SUBJECT: **INITIAL COMMENTS LETTER**

PROJECT NAME: NEIGHBORHOOD STORAGE @ SW HWY 484

PROJECT #2021030084

APPLICATION: MAJOR SITE PLAN #26499

SHEET
C002

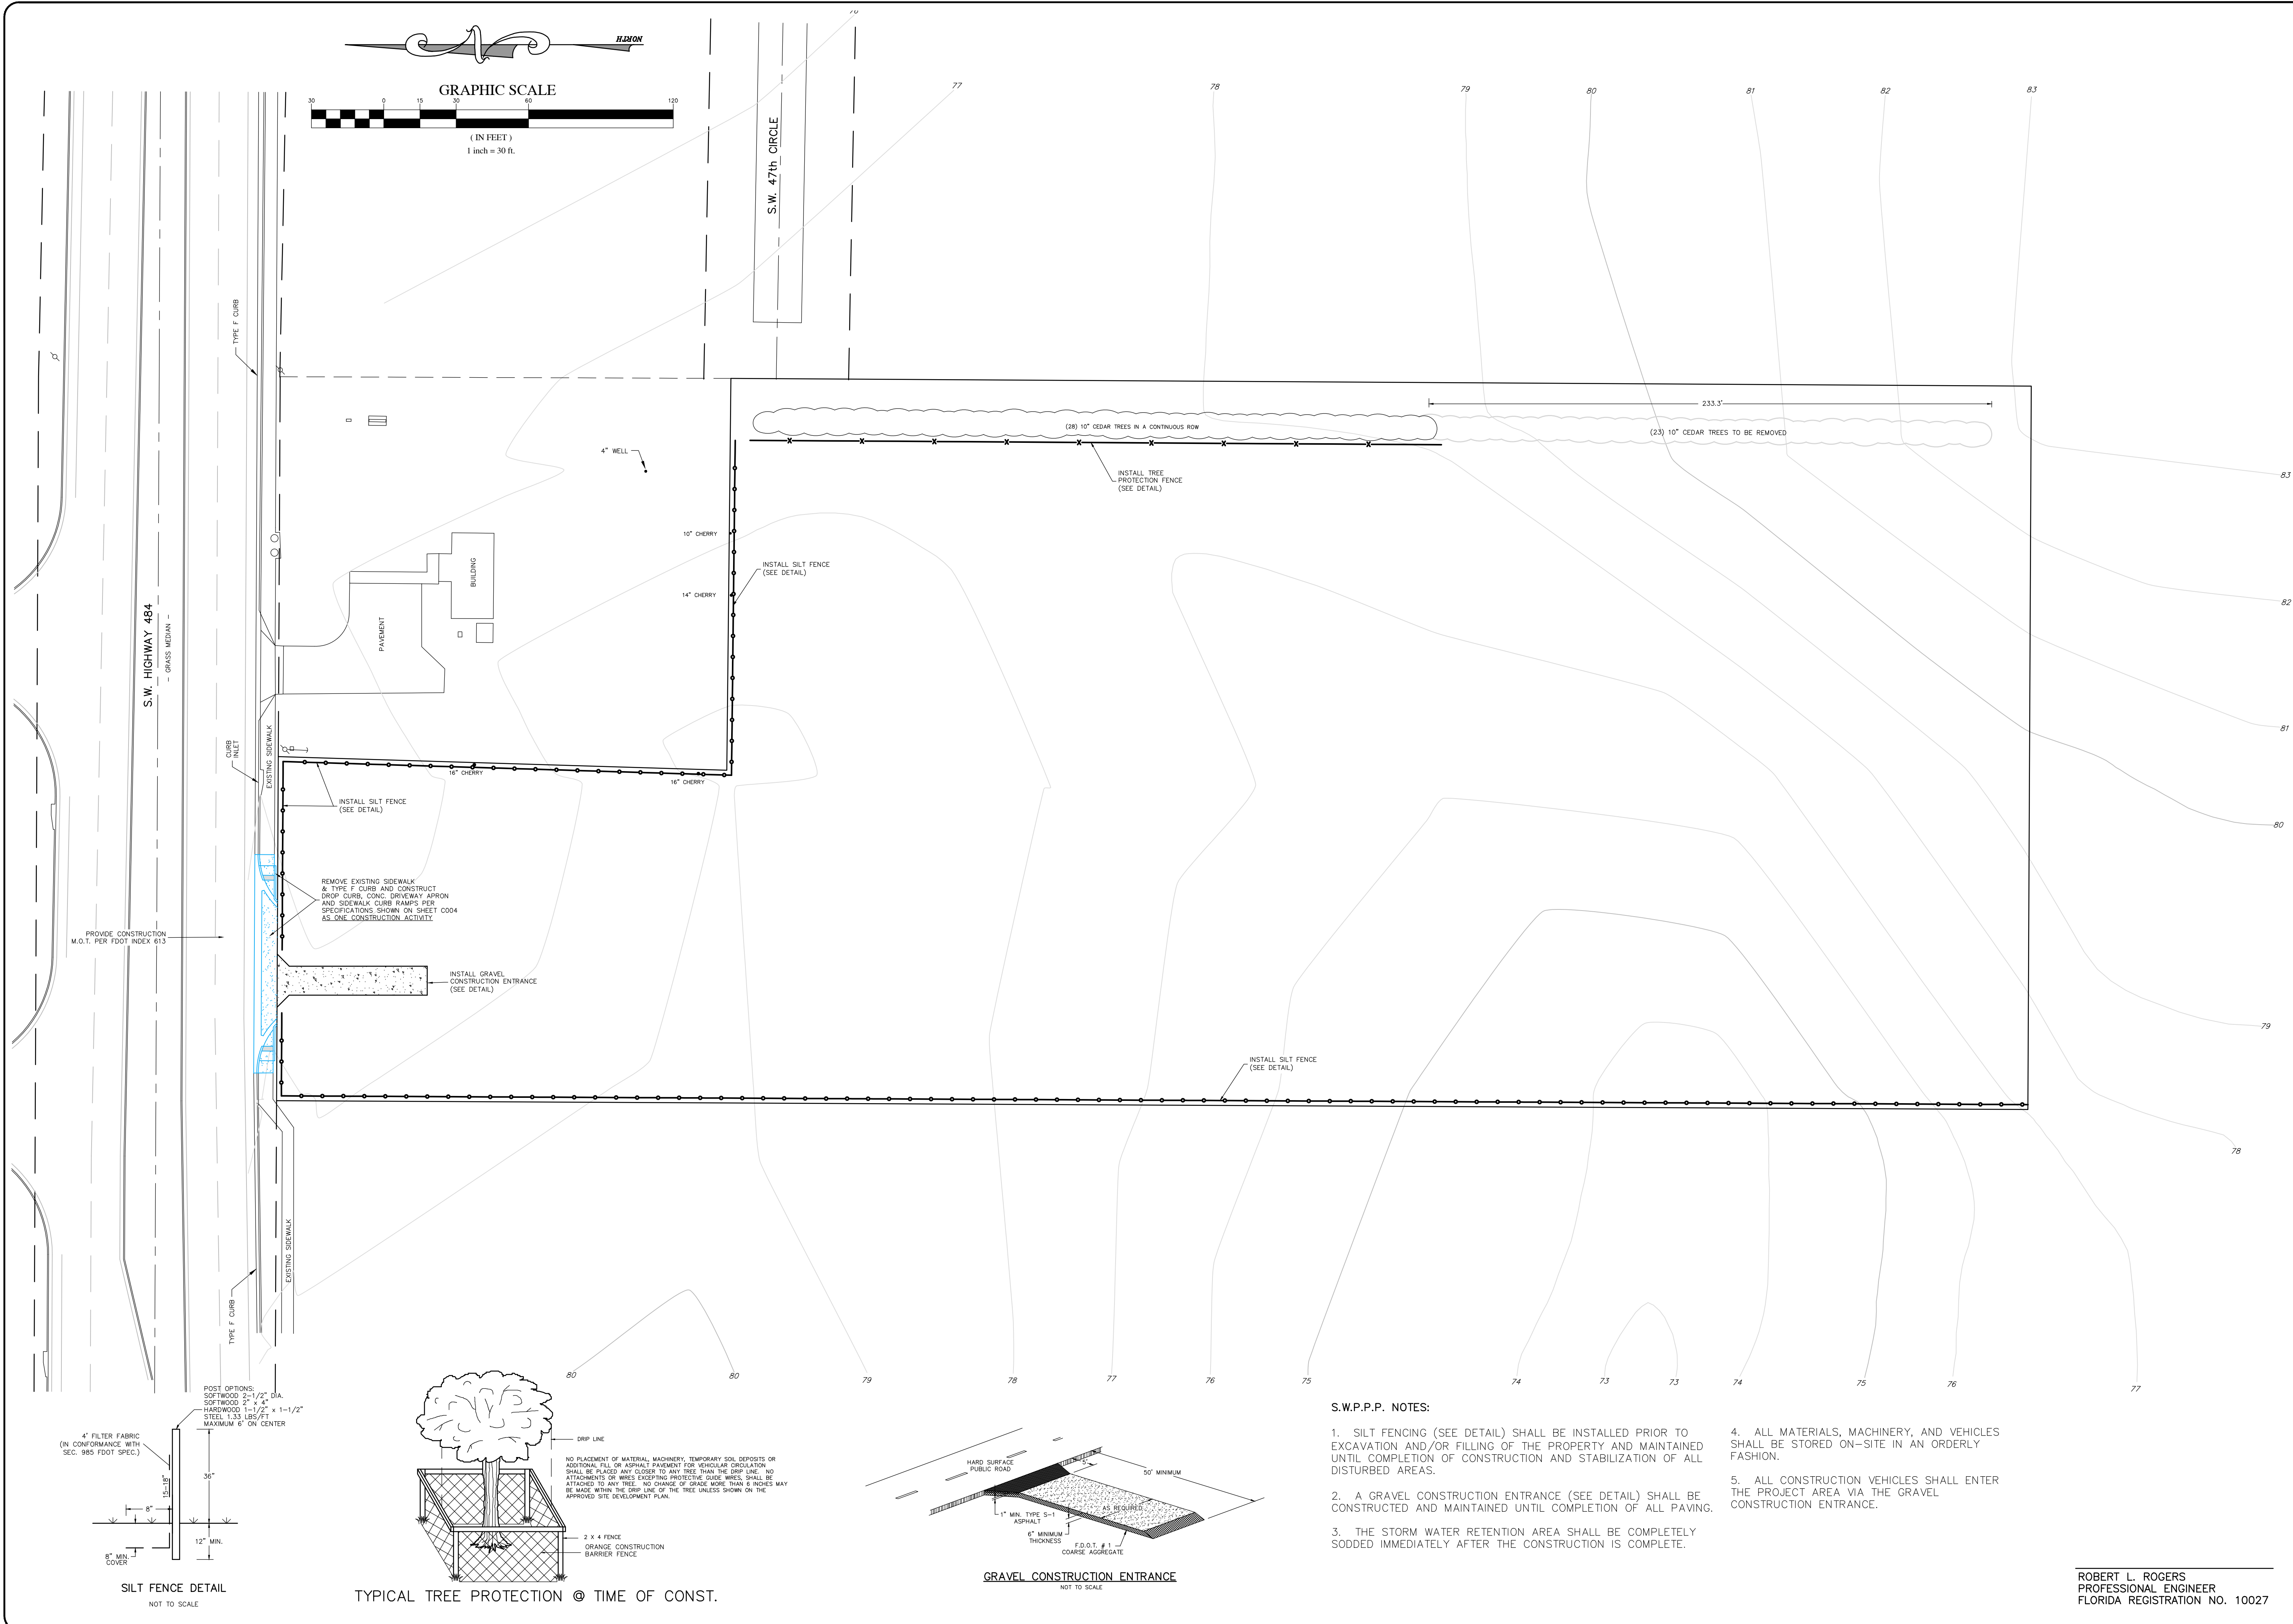
42. DEPARTMENT: 911 - 911 MANAGEMENT
REVIEW ITEM: Additional 911 comments
STATUS OF REVIEW: ENGINEER WILL COMPLY
REMARKS: Sheet C001 – Section is incorrect. It should be 9 not 16, Sheet C002 & C004 – There is an incorrect parcel number of 41205-003-00. It should be 41205-003-01.

S.W.P.P. & Tree Removal Plan

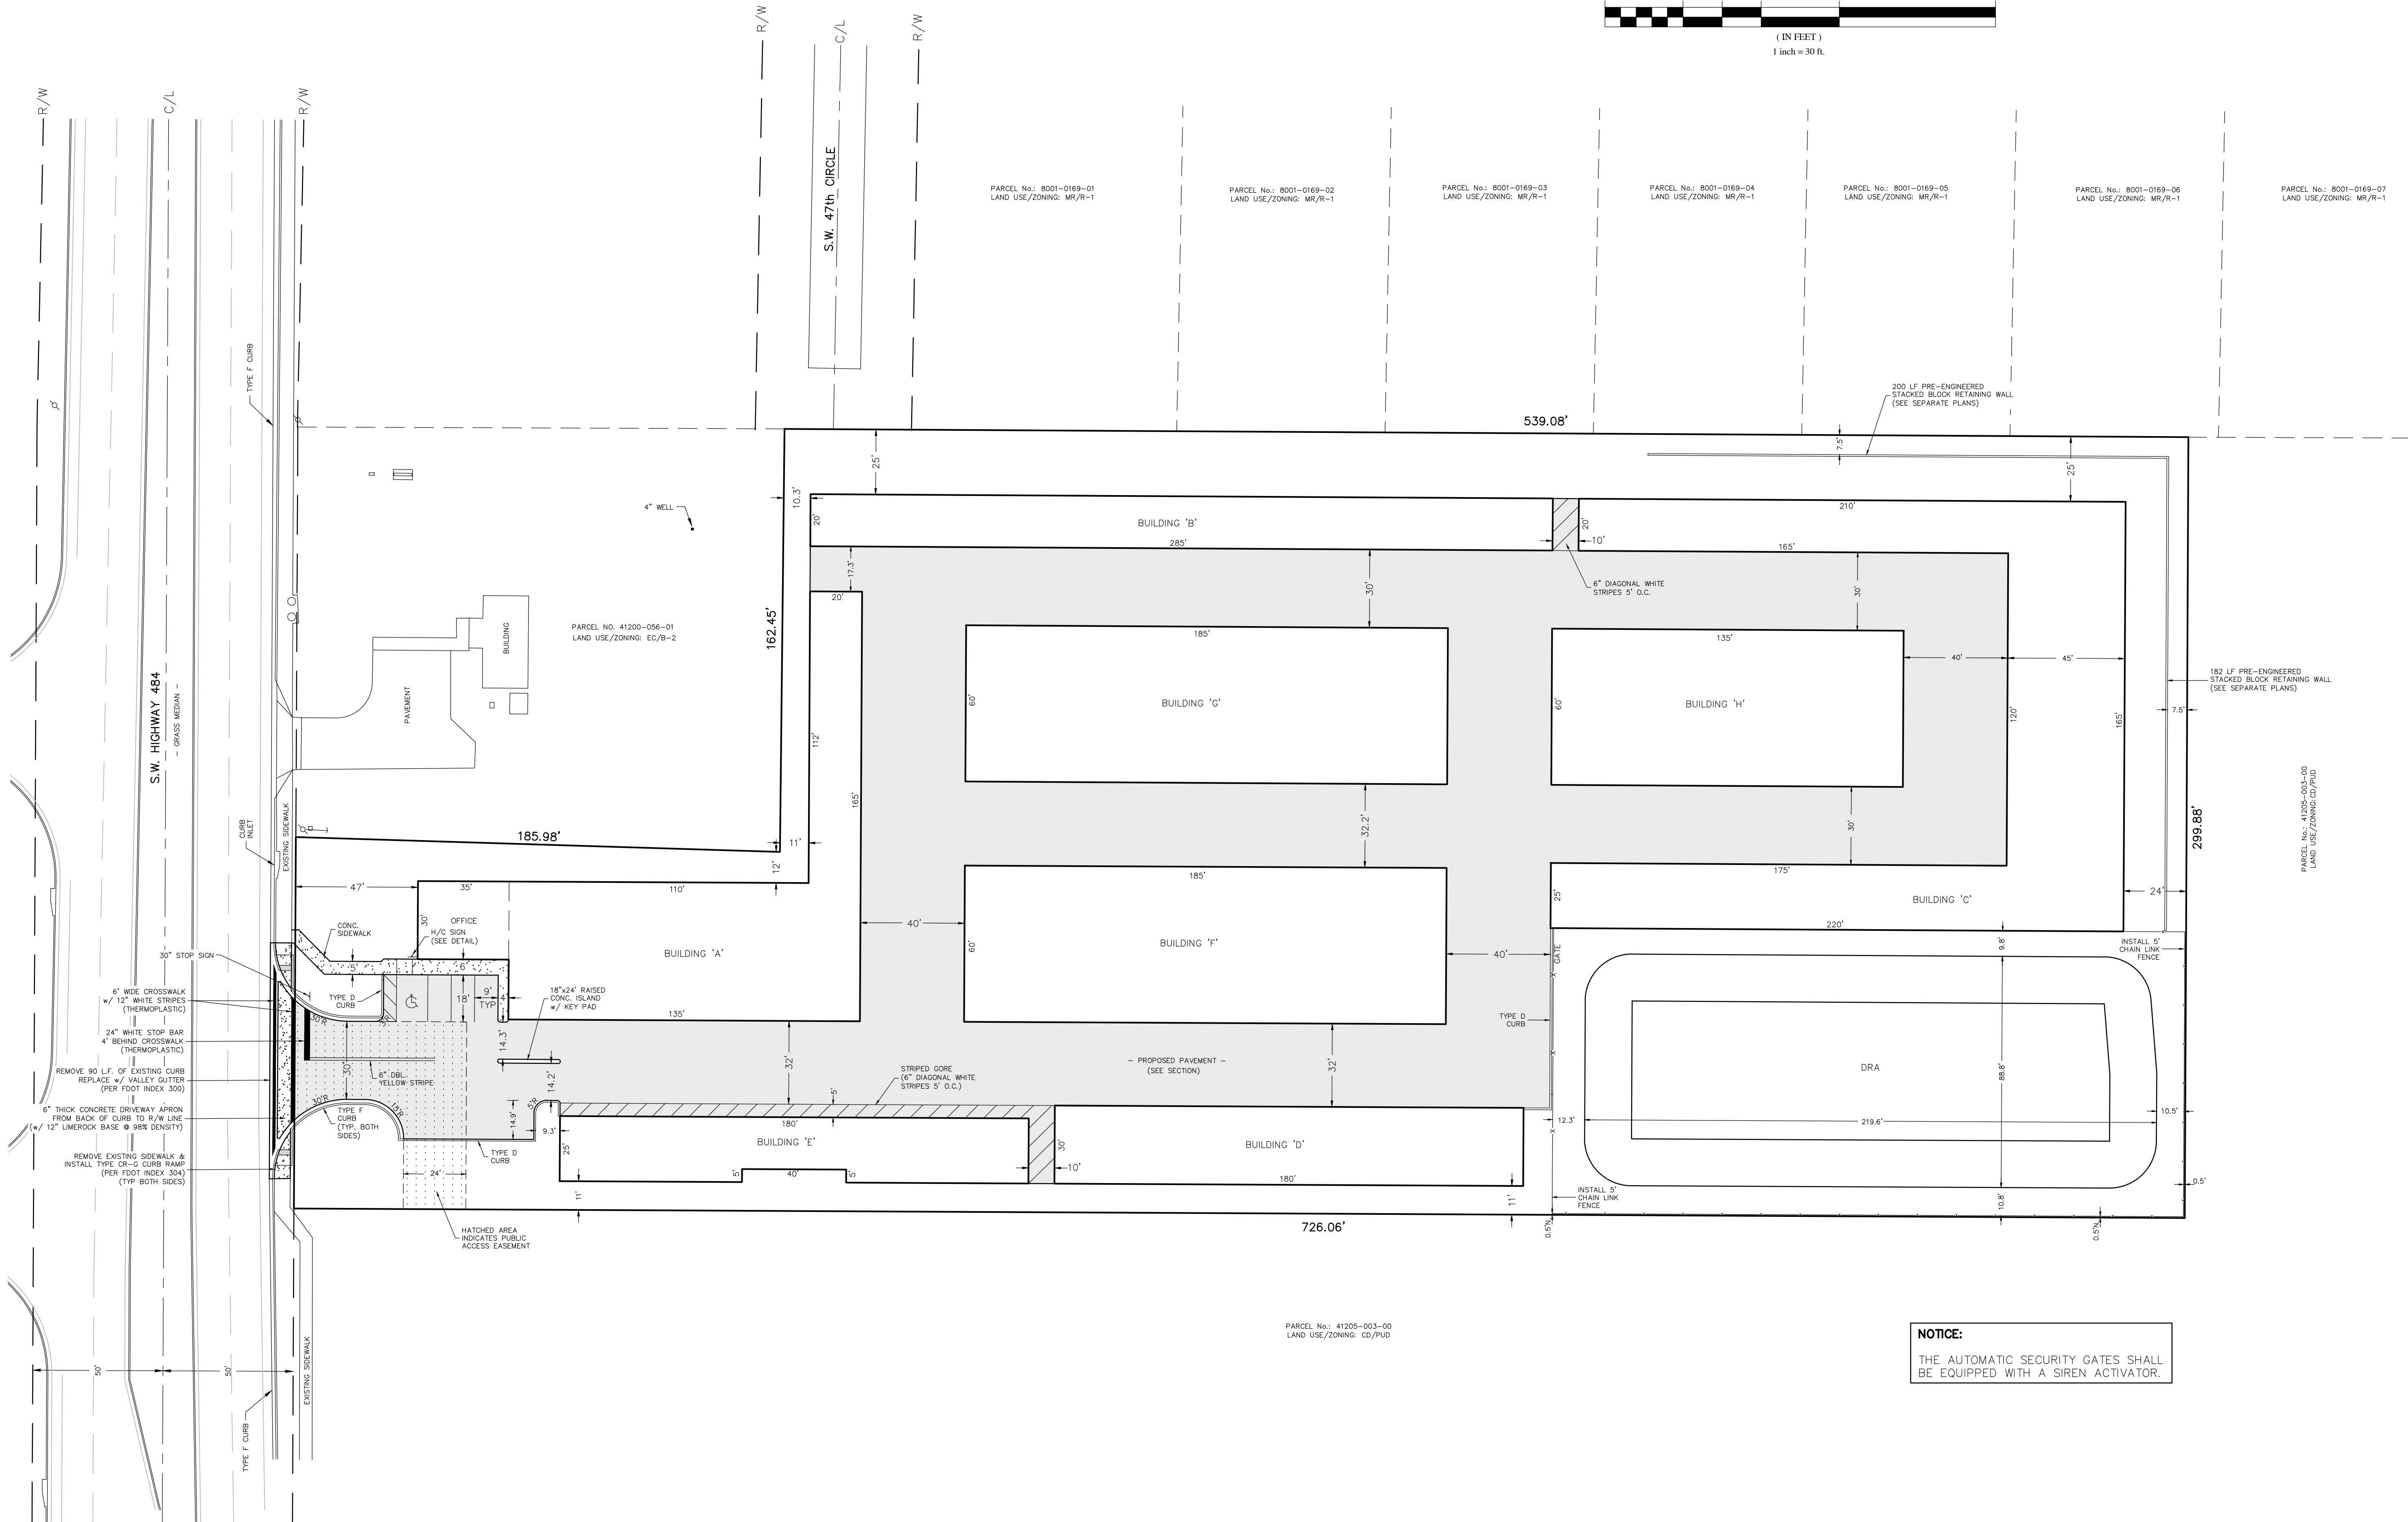
43. DEPARTMENT: LSCAPE - LANDSCAPE DESIGN AND IRRIGATION
REVIEW ITEM: 6.7.3 - Tree protection
STATUS OF REVIEW: N/A
REMARKS: Please provide detail
44. DEPARTMENT: LSCAPE - LANDSCAPE DESIGN AND IRRIGATION
REVIEW ITEM: 6.7.6 - Tree removal submittal requirements
STATUS OF REVIEW: N/A
REMARKS: Indicate trees to be removed

LANDSCAPE PLAN & NOTES
NEIGHBORHOOD STORAGE CENTER
SW HIGHWAY 484
MARION CO FLORIDA

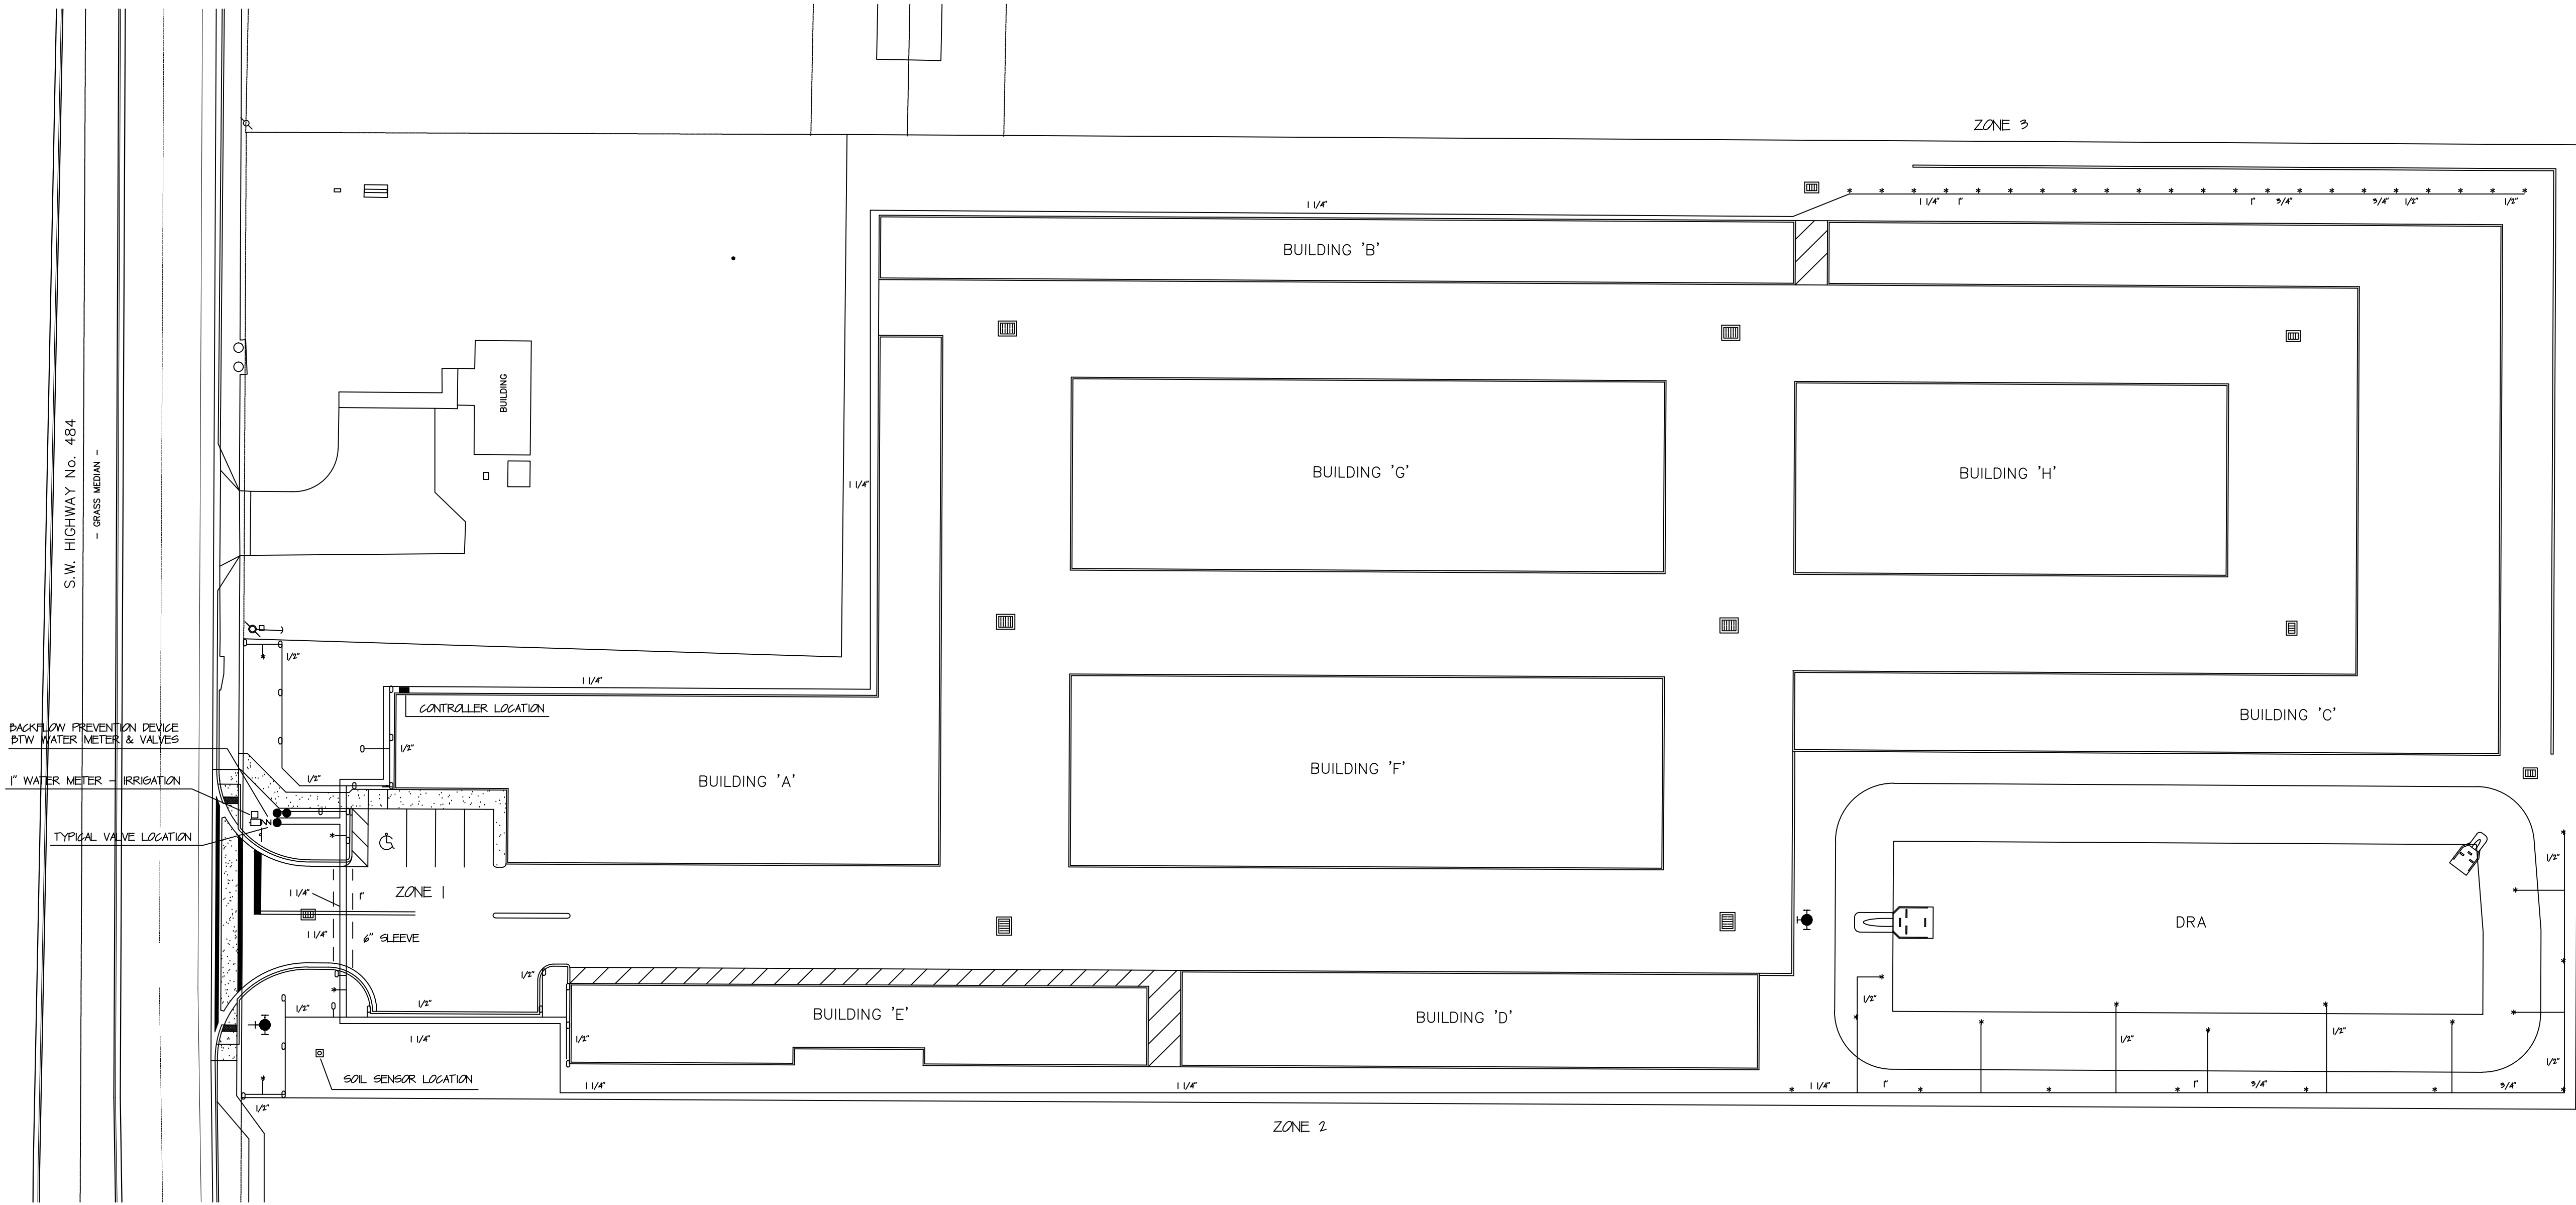
REMARKS: 1. East and South buffer information missing. 2. Buffer types for West and North buffers incorrect. 3. Buffer appear incomplete on plans, show plantings on East, West and South boundaries.
